TO	CHAIR AND MEMBERS	
то:	PLANNING AND ENVIROMENT COMMITTEE MEETING	
FROM:	GEORGE KOTSIFAS, P. ENG. MANAGING DIRECTOR, DEVELOPMENT AND COMPLIANCE SERVICES AND CHIEF BUILDING OFFICIAL	
SUBJECT:	APPLICATION BY: LONDON PROPERTY CORPORATION 124 ST. JAMES STREET PUBLIC SITE PLAN MEETING NOVEMBER 26, 2012 AFTER 4:15 PM

That on the recommendation of the Manager, Development Planning, the following actions be taken with respect to the site plan approval application of London Property Corporation for two, three and one-half storey thirty-six unit apartment buildings with each unit containing three bedrooms at 124 St. James Street:

S. Bellaire File No: SP12-032350

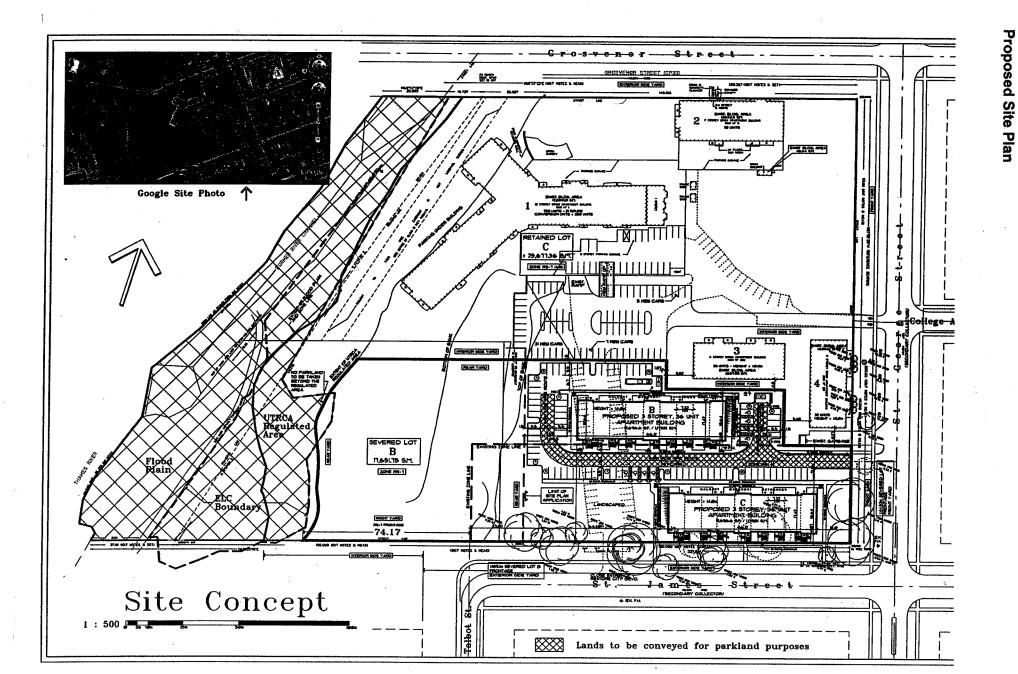
- Parking exposed to the public-right-of-way shall be screened through the use of landscaping and landscape features.
- Building C should be sited to ensure it maintains the St. George street line.
- Further comments from the Urban Design section are anticipated as the project moves through the site plan review process.

The proposal necessitates the removal of twelve trees including one street tree on St. George Street, two street trees on St. James Street and a mature black walnut located along the St. James Street frontage on private property. In order to protect the mature black walnut tree from any impacts, the building would have to be located thirty-five metres west of its existing location and that would impact the three other existing private trees or ten metres north of its existing

# roposed Landscape Pla

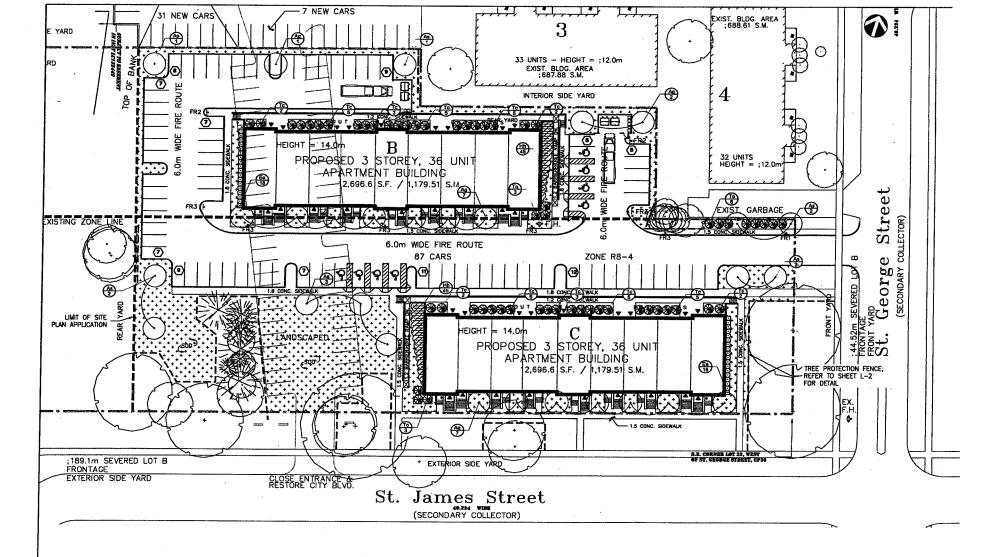
The current landscape plans attempts to satisfy some of these principles however improvements to the design will have to be made to define public space from private outdoor spaces, propose more native and ecologically appropriate species, employ foundation plantings and plantings to shade, visually enhance and screen surface parking areas and plant additional street trees as required. It is expected that all of these items can be sufficiently addressed through subsequent revisions to the landscape plan. The applicant submitted a tree preservation report and plan with the site plan application and has identified thirteen trees within the subject property to be preserved with sufficient tree protection fencing and twelve trees to be removed as a result of this development.
